STATE OF NEW YORK
OFFICE OF GENERAL SERVICES
DESIGN AND CONSTRUCTION GROUP
THE GOVERNOR NELSON A. ROCKEFELLER
EMPIRE STATE PLAZA
ALBANY, NY 12242

ADDENDUM NO. 2 TO PROJECT NO. 44808

**CONSTRUCTION WORK, HVAC WORK, PLUMBING WORK, AND ELECTRICAL WORK
RENOVATE BUILDING NO. 5
STATE OFFICE BUILDING CAMPUS
1220 WASHINGTON AVENUE
ALBANY, NY**

November 19, 2013

1
A-415
SCALE: 1/4" = 1'-0"

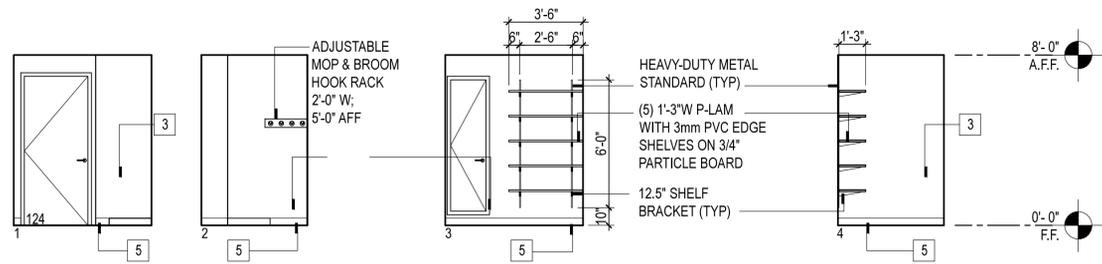
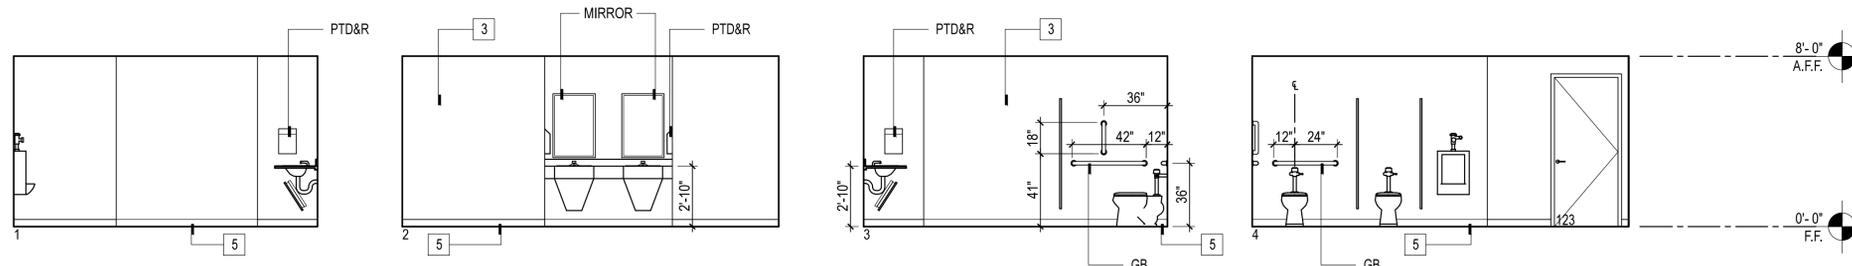
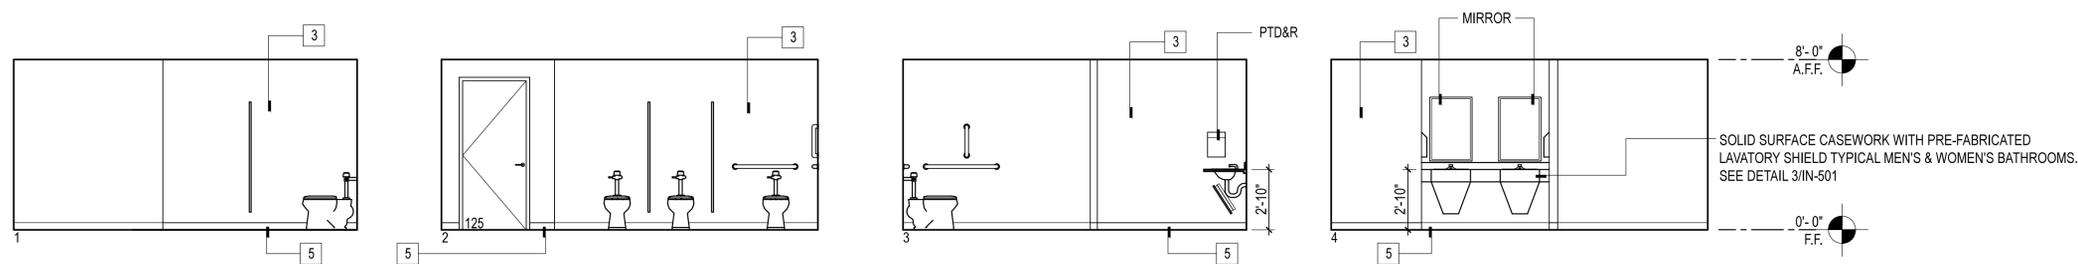
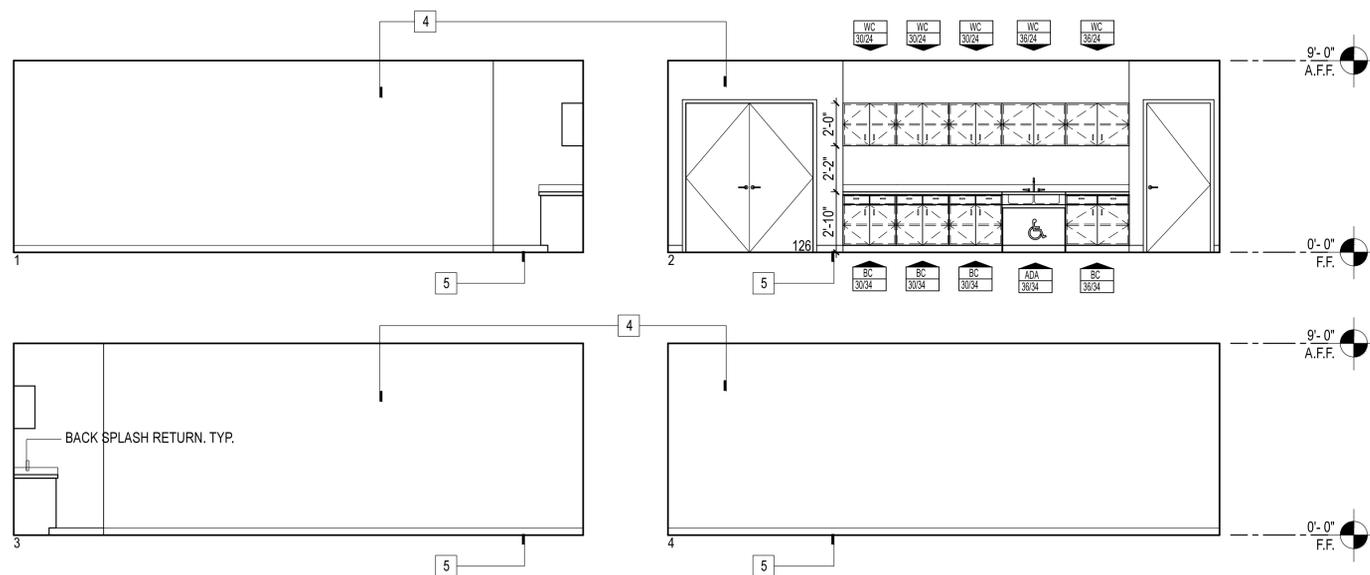
- a. Note G5: Change this Note to read “Refer to casework details on Drawing No. IN-501”.
 - b. Add the following Note:
“G7. “All wall mounted components shall have wood blocking placed in walls to meet specified anchoring requirements”

E-201

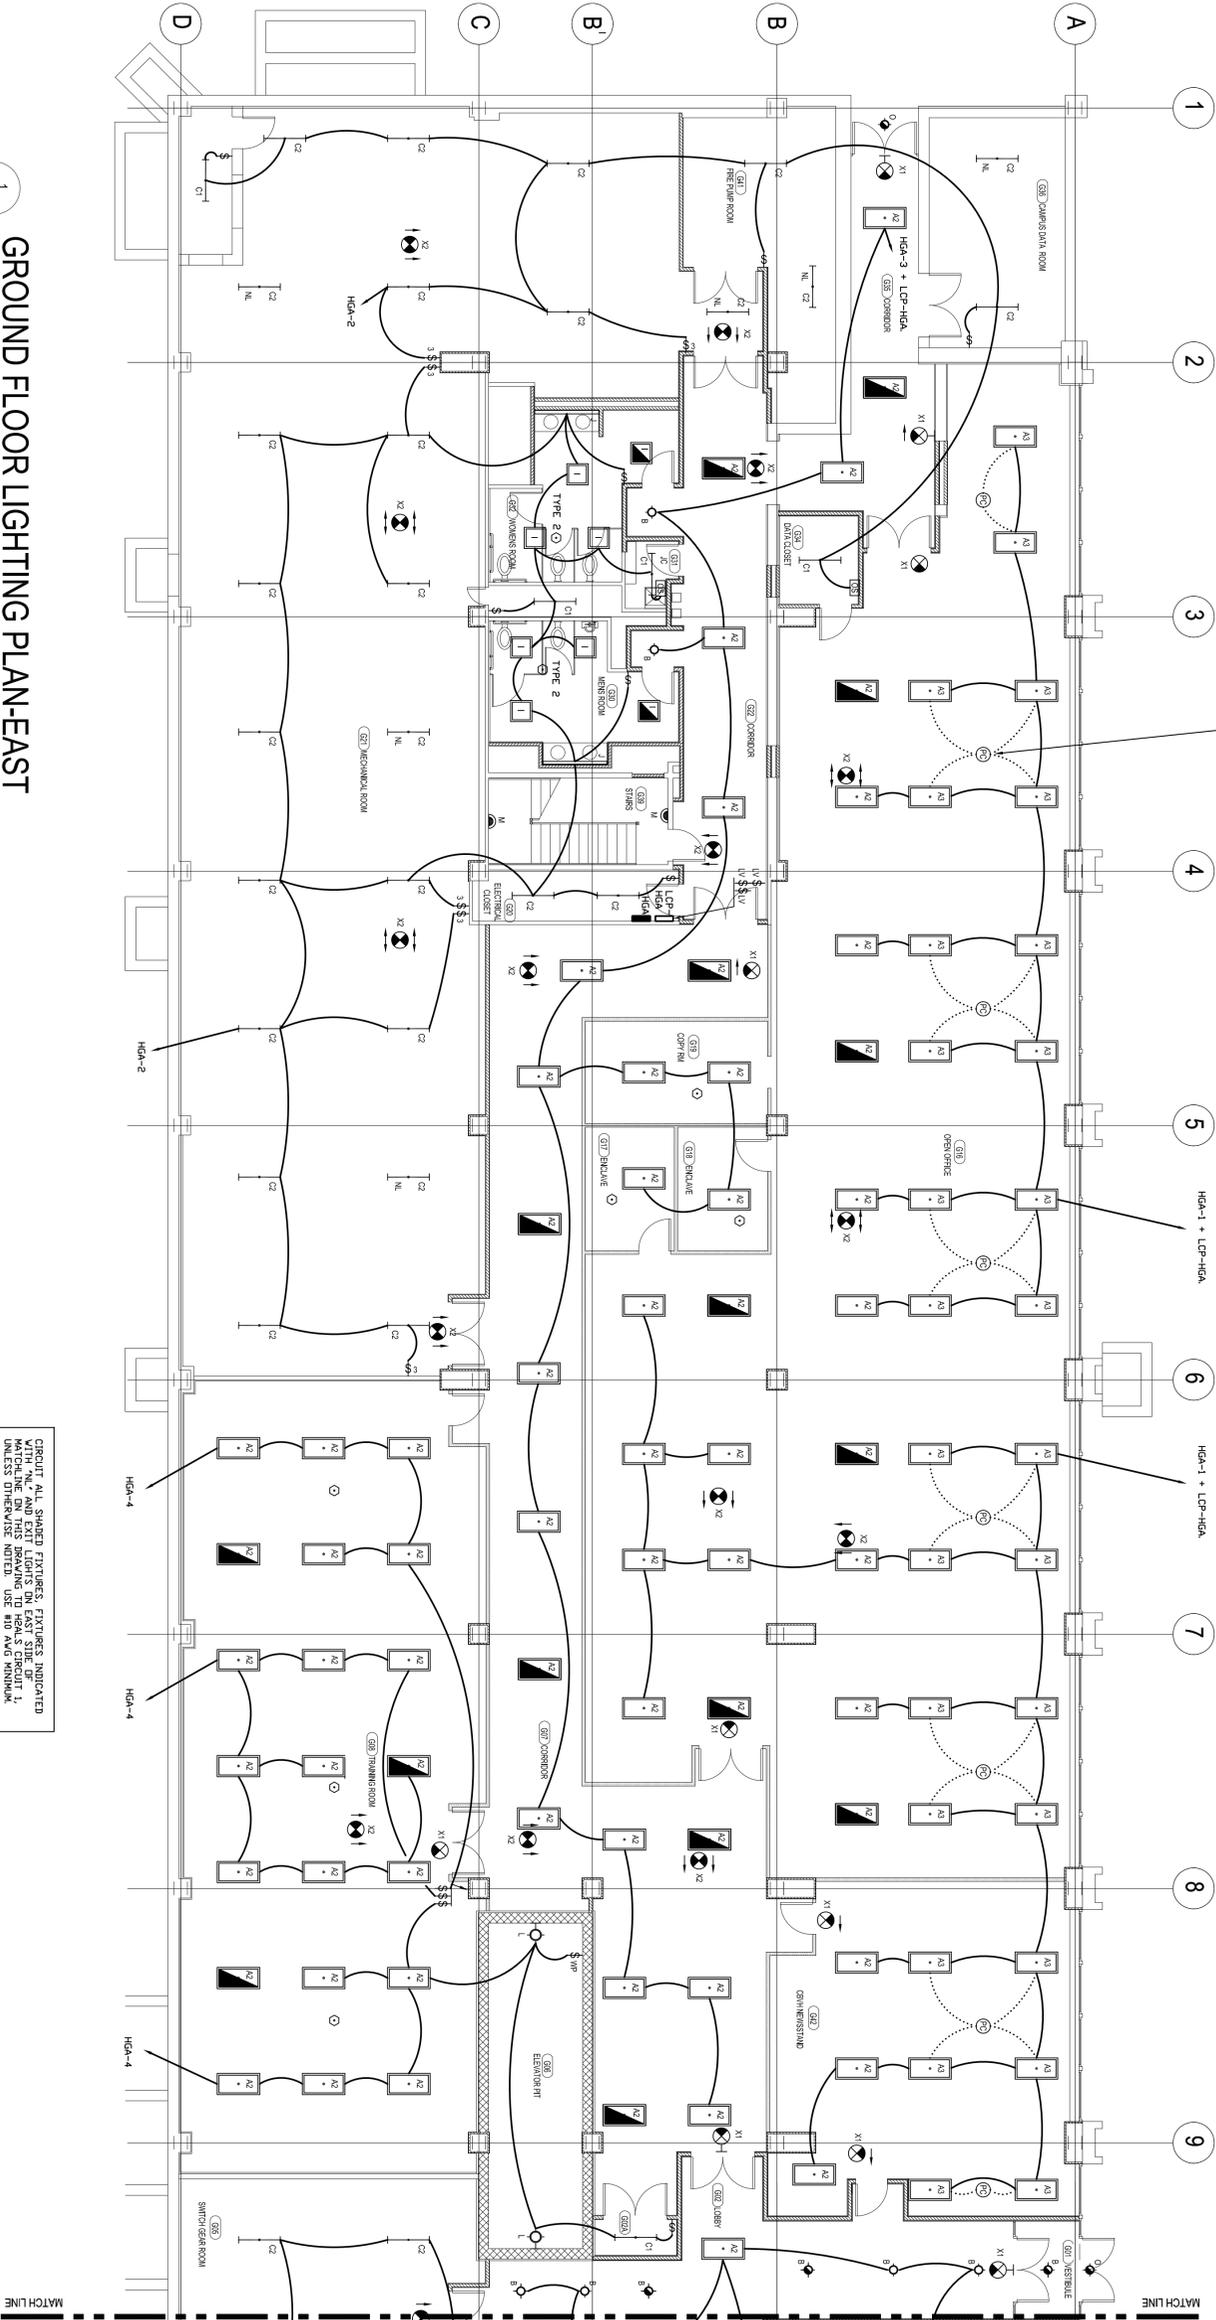
56. General: Drawing Nos. IN-901 thru IN-962 as shown on Drawing No. G-001, refer to Construction Work Contract on the CD. HVAC Work, Plumbing Work, and Electrical Work Contractors shall use these drawings for reference purposes and coordination.
57. Drawing No. E-203, FIRST FLOOR LIGHTING PLAN – EAST:
- a. Add (3) surface mounted shaded (emergency power backed) “Type O” fixtures on the underside of canopy to the west of loading dock (evenly spaced within soffit). Circuit to H2CLS Circuit 3.
 - b. LIGHTING RELAY CONTROL PANEL LCP-H1A SCHEDULE: Change “H1A-7” line feed for Relay No. 8 to read “H1A-15”.
58. Drawing E-215, PENTHOUSE FLOOR LIGHTING PLAN - EAST: Add (1) Type O shaded wall pack (emergency power backed) on the east side of building (to the south on man door). Mount fixture at 6’-6” aff. Circuit to H5CLS Circuit 7.

DRAWING NUMBER:
G-005

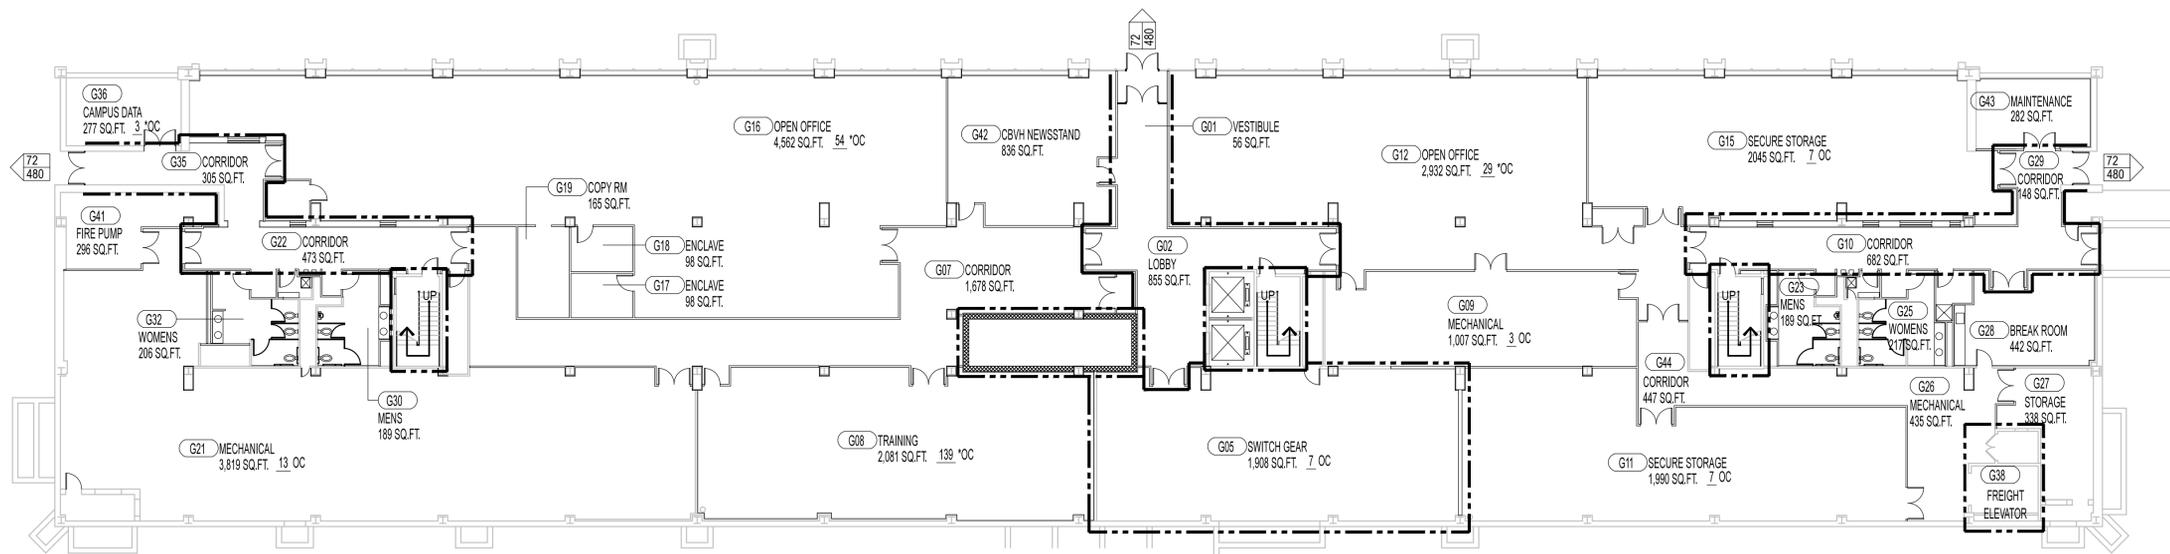
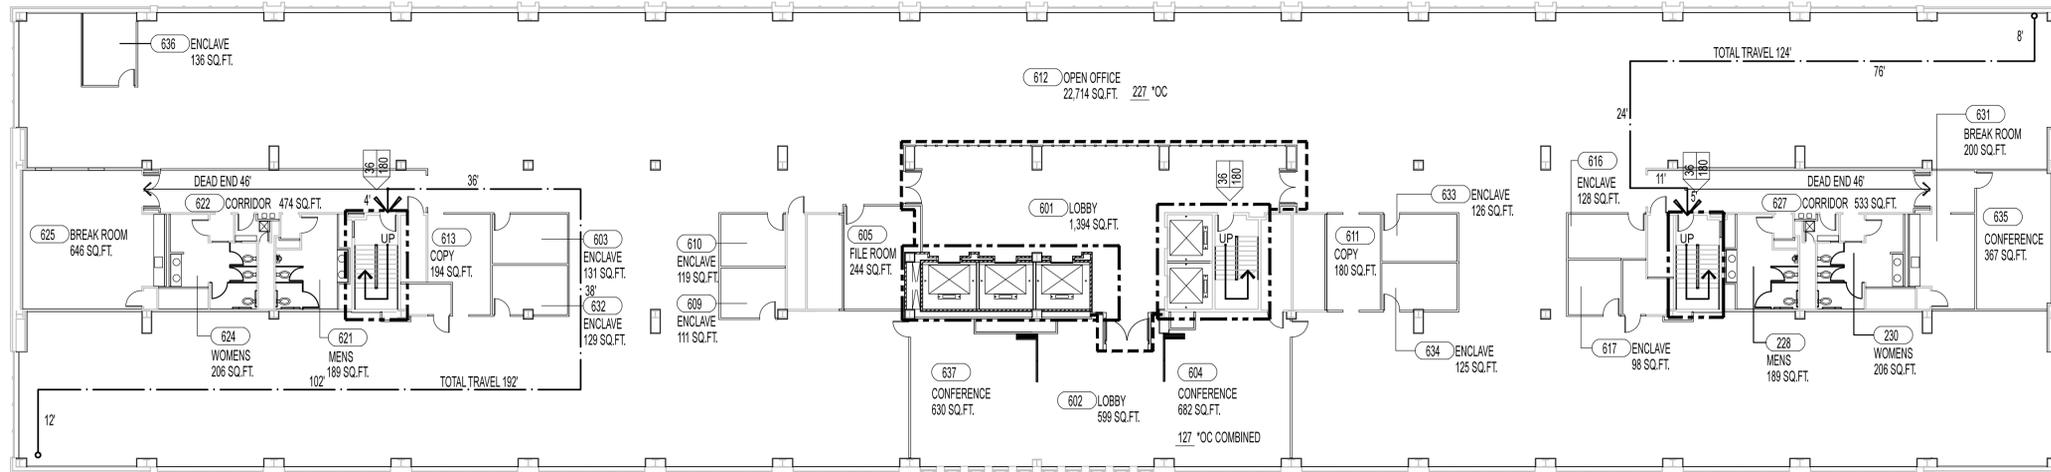
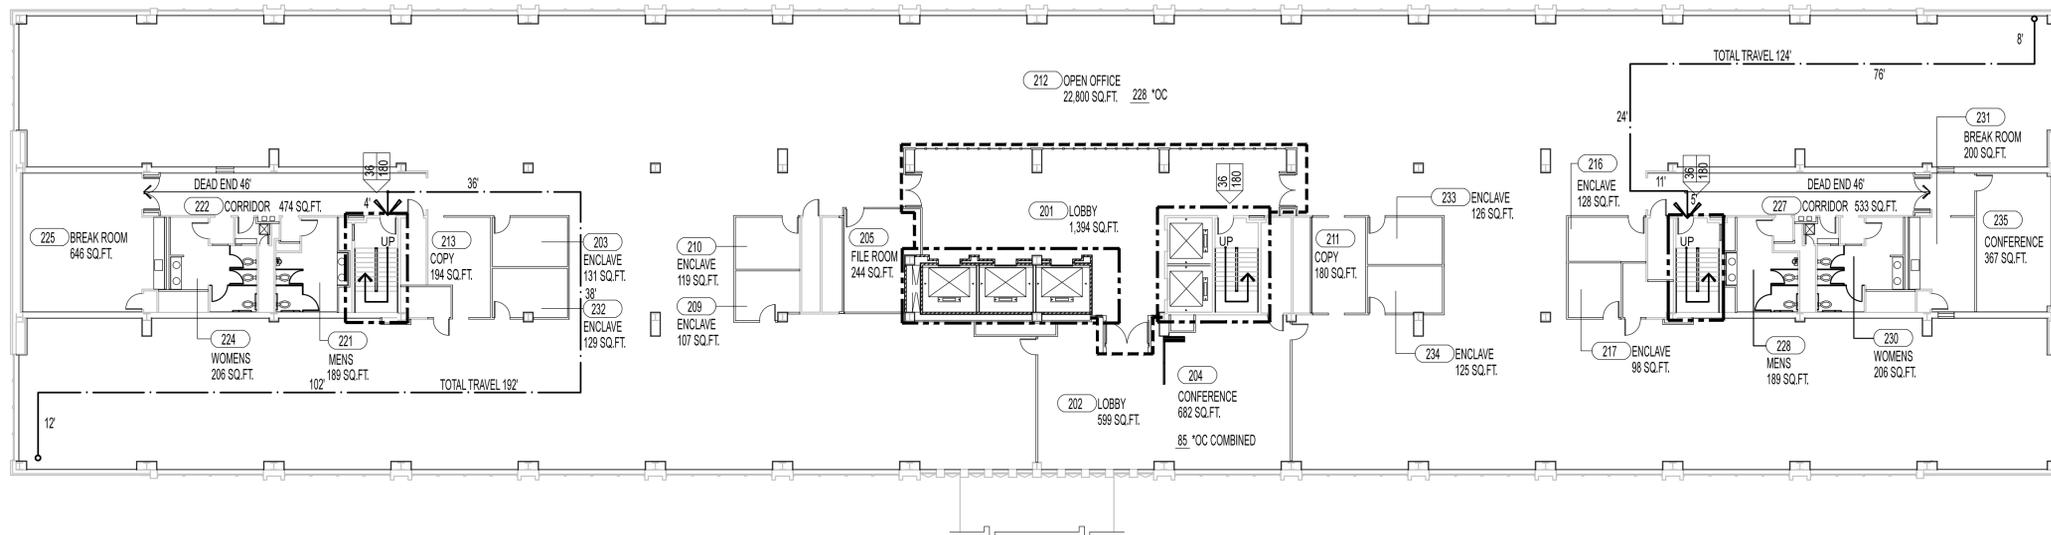
- a. Drawing Nos.G-005, and G-006 noted “REVISED DRAWING 11/18/13”, accompany this Addendum and supersede the same numbered originally issued drawings.

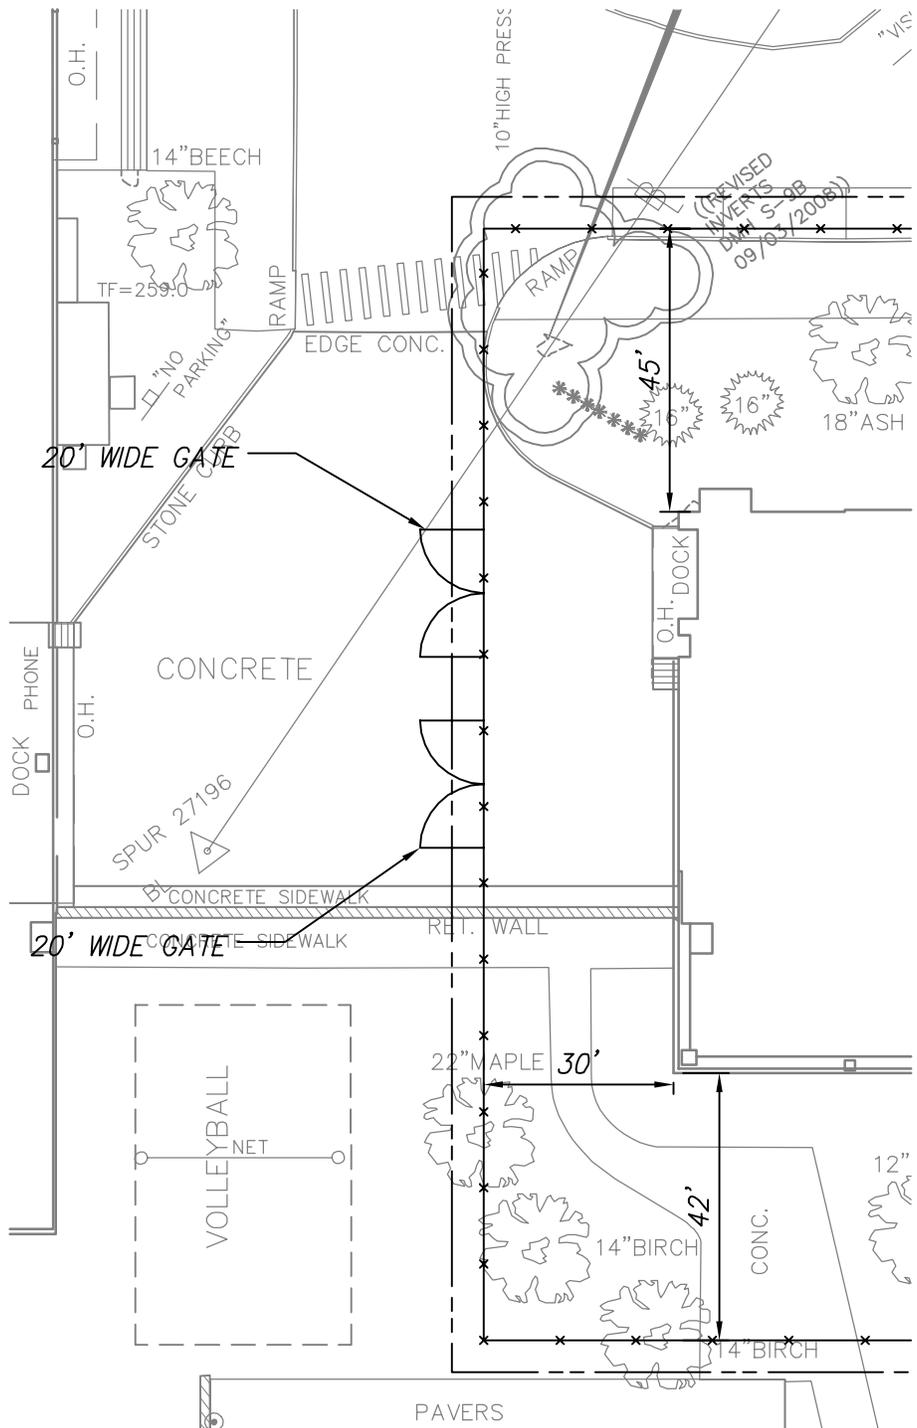
13. Drawing No. G-003, SITE MOBILIZATION PLAN: Modify Temporary fence along the west side of Building No. 5 from “42 feet” to “30 feet +/-” off of Building No. 5 face. Refer to Addendum Drawing G-007 dated 11/18/13.
14. Addendum Drawings:
 - a. Drawing No. G-007, noted “ADDENDUM DRAWING 11/18/13”, accompanies this Addendum, and forms part of the Contract Documents.
15. Revised Drawings:
